### STAFF RECOMMENDATION 1401 Paris Avenue February 17, 2016

**Application:** New construction—addition and Detached Accessory Dwelling Unit;  
Setback determination

**Description of Project:** Application is to construct an addition that is wider than the historic house and includes a ridge raise, and to construct a Detached Accessory Dwelling Unit (DADU). The DADU requires a rear setback determination, as base zoning requires a twenty foot (20') rear setback and the applicant is proposing a three foot (3') rear setback.

Figure 2 (left) is an image of the addition to be demolished and Figure 3 (right) is the 1957 Sanborn Map.

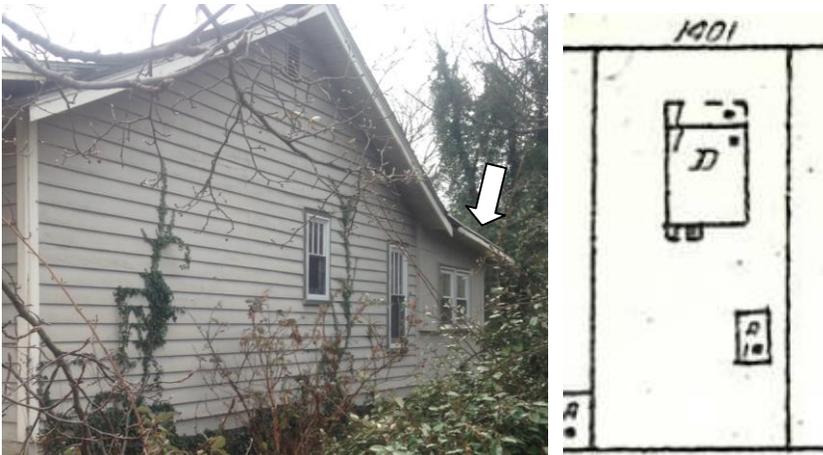
Partial Demolition: The project involves removing an existing addition at the rear of the house (Figure 2). The date of construction of the addition is unknown. The 1957 Sanborn map shows that it was formerly a rear porch, but it was much smaller than it is now (Figure 3). Staff finds that the addition does not contribute to the historic character of the house. Staff finds that its demolition meets Section V.B.2. for appropriate demolition and does not meet Section V.B.1. for inappropriate demolition.

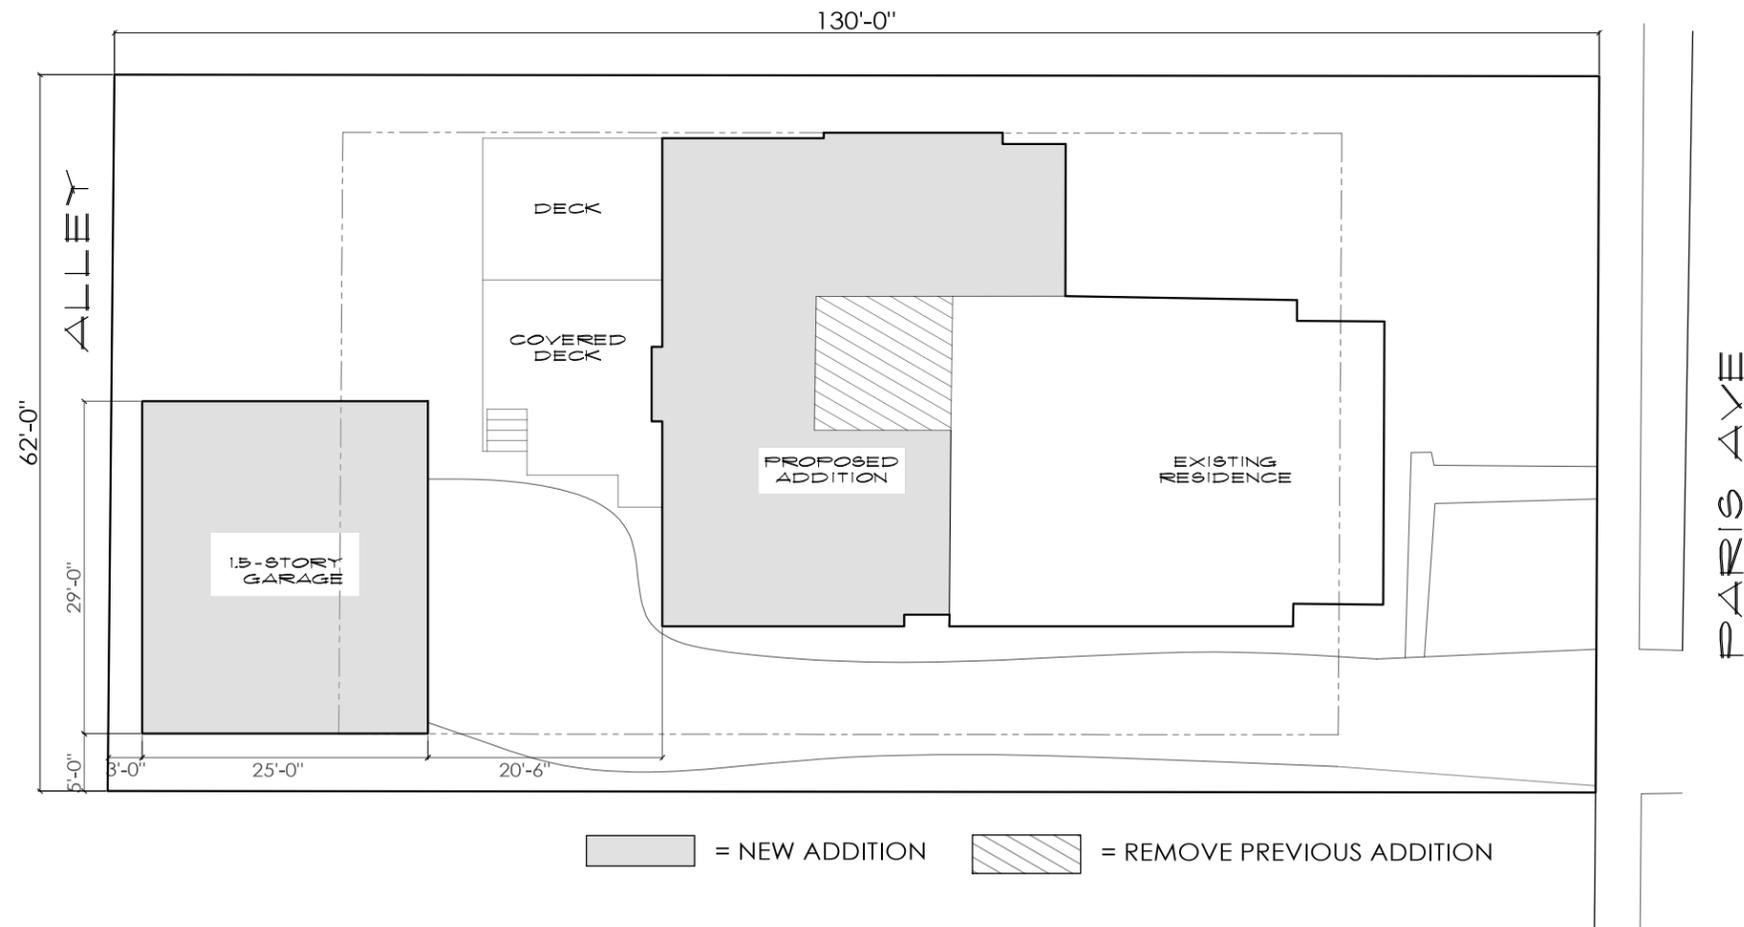
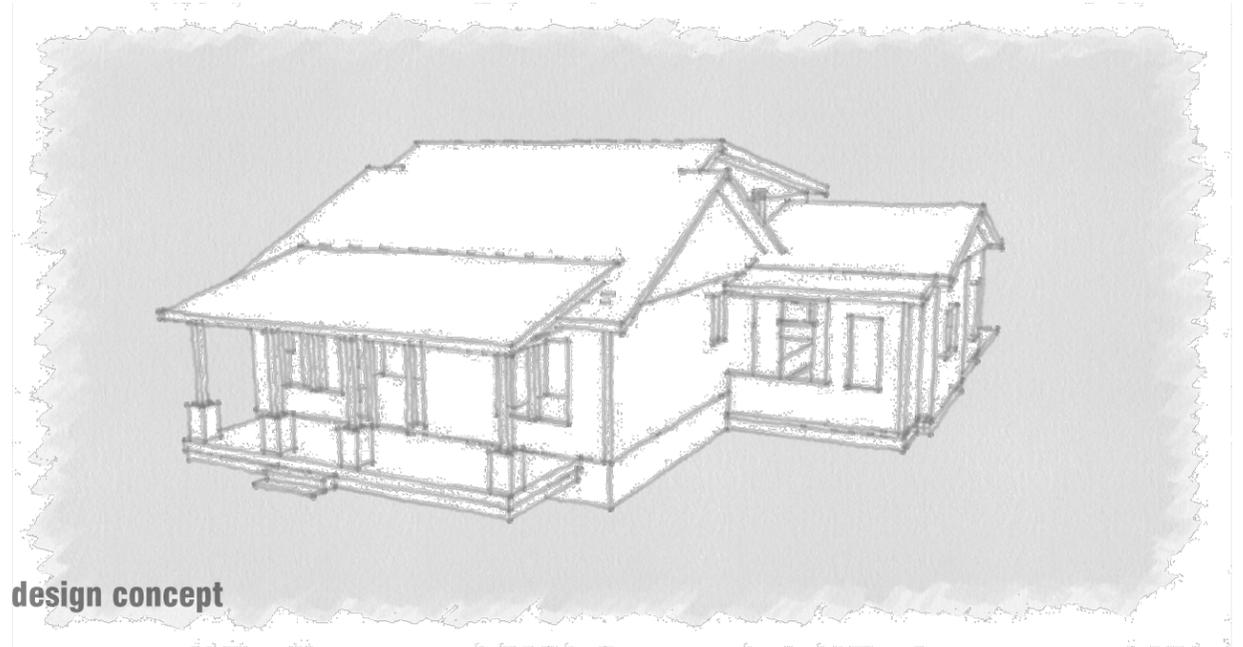
DADUs. Although the distance between the DADU and the primary rear wall of the house is twenty feet (20'), the distance between the DADU and the covered deck at the back of the house is less than five feet (5'). Staff considers the covered deck to be part of the house, and recommends that the distance between the DADU and the covered deck be a minimum of ten feet (10'). Staff finds that the ten foot (10') distance is appropriate because the lot is relatively shallow at approximately one hundred and thirty feet (130') deep, and because in most places, the distance between the DADU and the rear wall of the house is at least twenty feet (20'). This may be accomplished by removing approximately one hundred and fifty-five square feet (155 sq.ft.) from the addition overall, as discussed under "Height & Scale."

The new outbuilding requires a rear setback determination. When an outbuilding has a footprint greater than seven hundred square feet (700 sq. ft.), base zoning requires that the structure be located twenty feet (20') from the rear property line and five feet (5') from the side property lines. In this instance, the structure is located at least five feet (5') from the side property lines, but it is located three feet (3') from the rear property line. Staff finds that the proposed rear setback is appropriate because the garage doors do not face the alley, and a three foot (3') setback is the standard rear setback for structures that are seven hundred square feet (700 sq. ft.) or less. Also, historically, outbuildings were located at the rear of the property, close to the rear property line. A three foot (3') rear setback is more historically appropriate than a twenty foot (20') rear setback. In addition, the three foot (3') rear setback allows for more space between the primary structure and the DADU. Staff recommends approval of the setback determination.

**A1.0** main floor plan

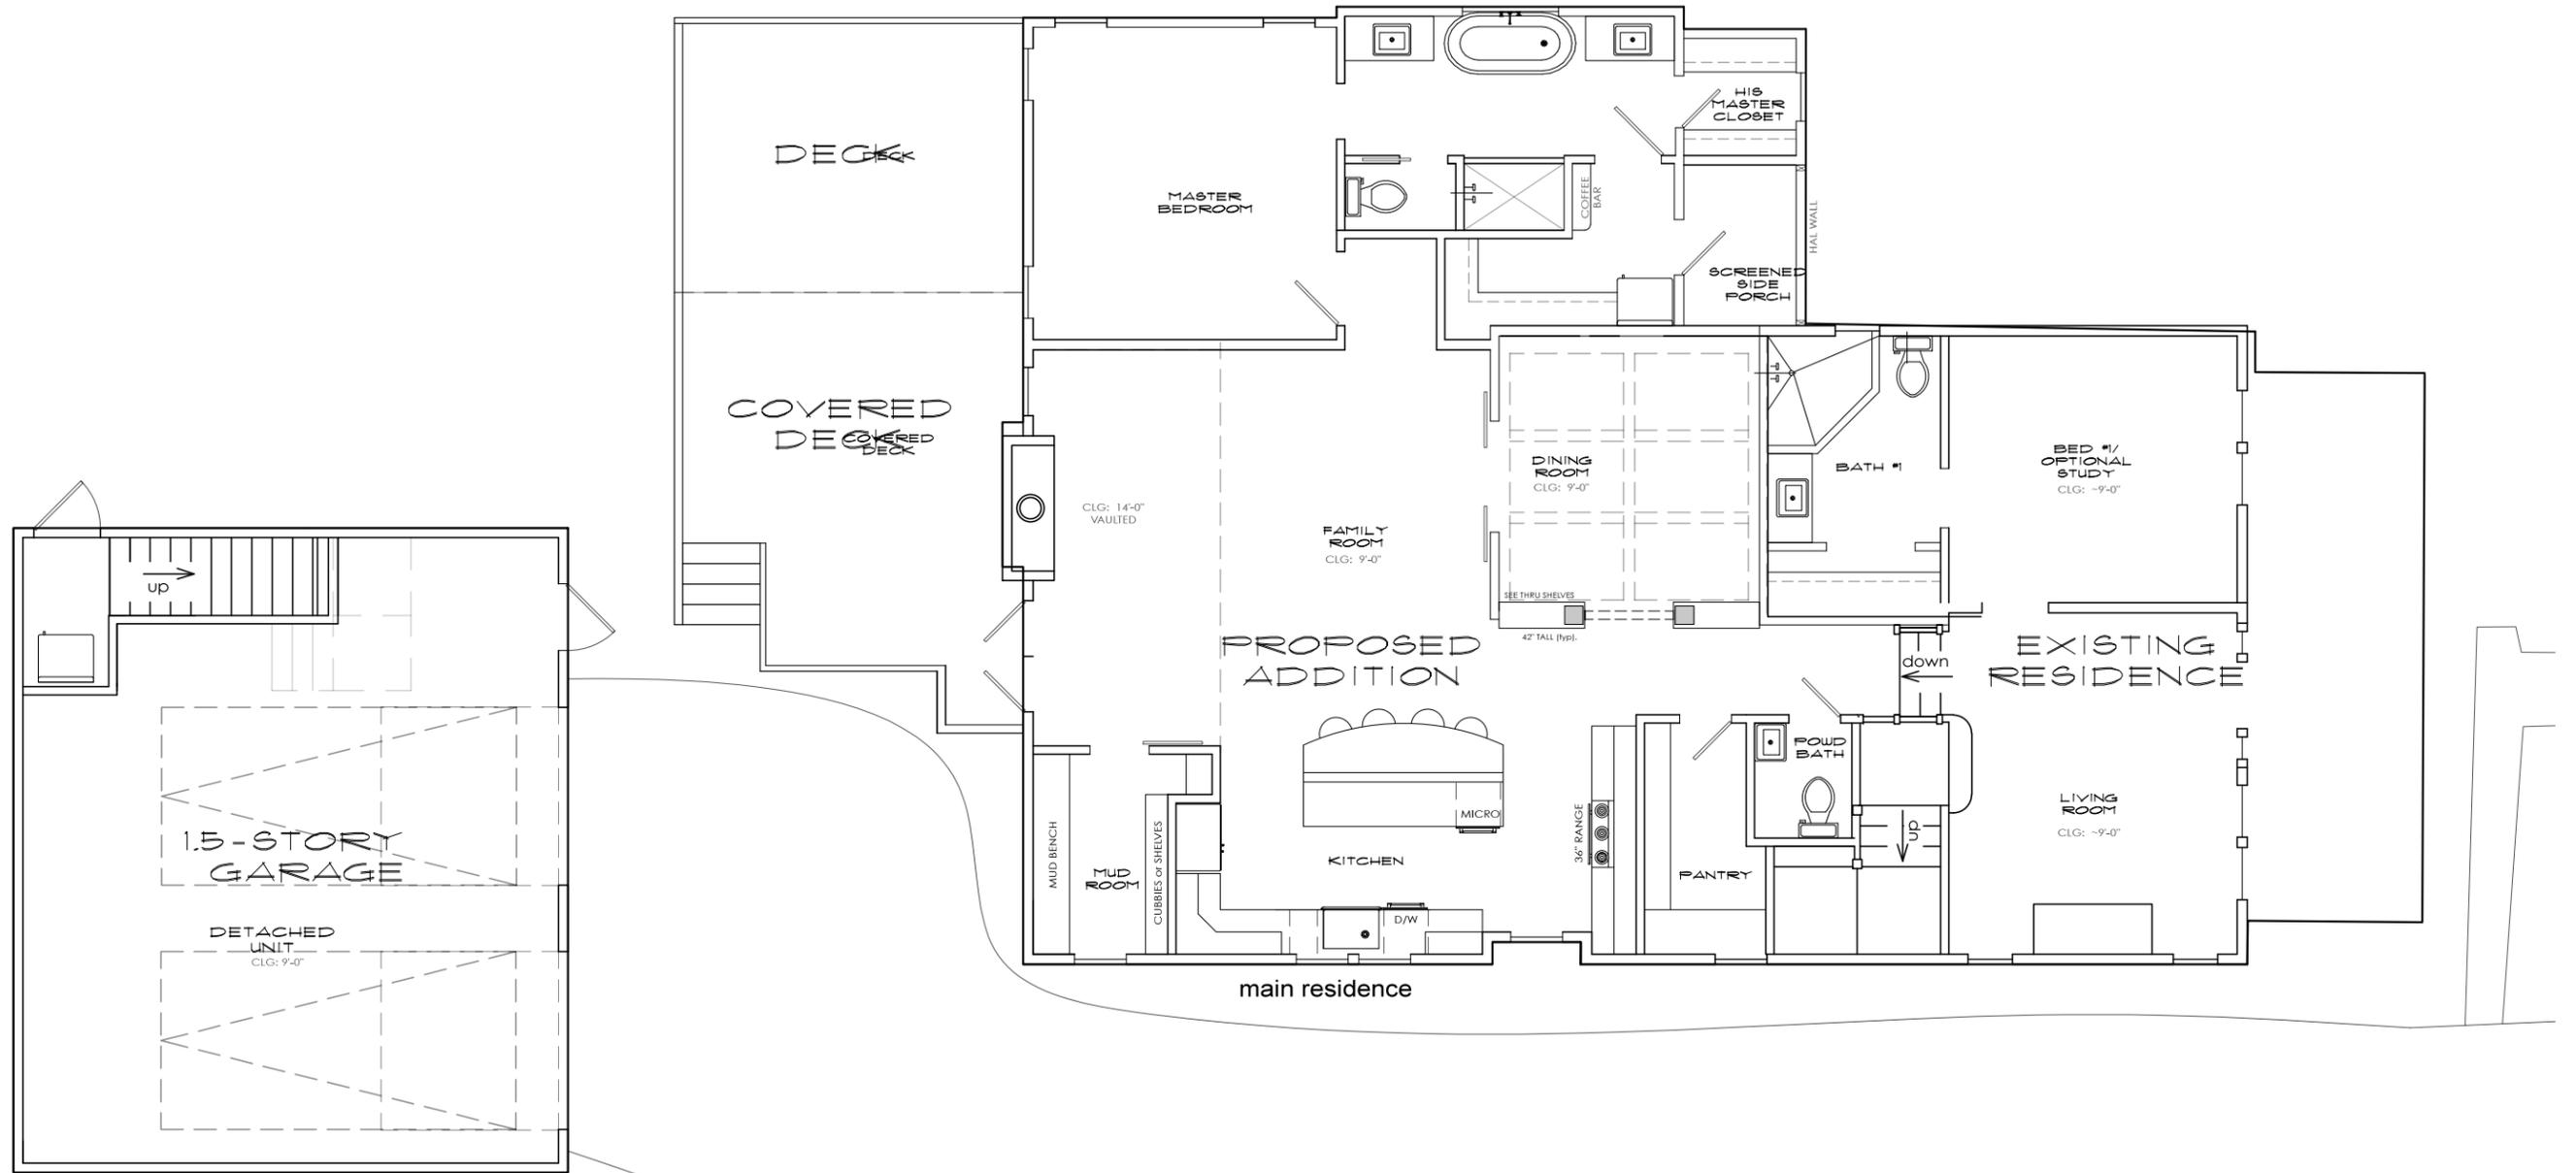
Height & Scale: The proposed addition is inset two feet (2') from the back left corner of the house. However, on the right side, there is a side addition that wraps the corner of the house. Staff finds that a side addition is appropriate here because the lot is sixty-two feet (62') wide, wider than the typical lot, and because the house is unusually narrow at approximately twenty-nine feet (29'). The side addition is subordinate to the historic house by being fourteen feet, six inches (14'6") wide and three feet, six inches (3'6") shorter than the historic house. It will be located twenty feet (20') back from the front wall of the house and will have a side gable roof form to help lessen the perceived height.

The proposed addition involves a two-foot (2') ridge raise that is inset two feet from the sidewalls. The enclosed portion of the addition will have a depth of approximately twenty-five feet (25') from the back wall of the historic house. The enclosed portion of the addition will approximately double the footprint of the historic house. However, when the covered rear deck is included, the addition more than doubles the footprint of the historic house. Staff asks that the addition's footprint be reduced so that it no more than doubles the footprint of the historic house, including all covered porches. This would require a reduction of approximately one hundred and fifty-five sq. ft. (155 sq. ft.).

1. The footprint of the addition be reduced by a minimum of one hundred and fifty-five square feet (155 sq. ft.) so that it no more than doubles the footprint of the historic house;
2. Staff approve the final details, dimensions and materials of windows and doors prior to purchase and installation;
3. The HVAC be located behind the house or on either side, beyond the mid-point of the house;
4. Staff approve the roof color;
5. The distance between the DADU and the covered deck be a minimum of ten feet (10'), and the distance between the DADU and the primary back wall of the house remain twenty feet (20'); and
6. Staff receive a copy of the restrictive covenant for the Detached Accessory Dwelling Unit.
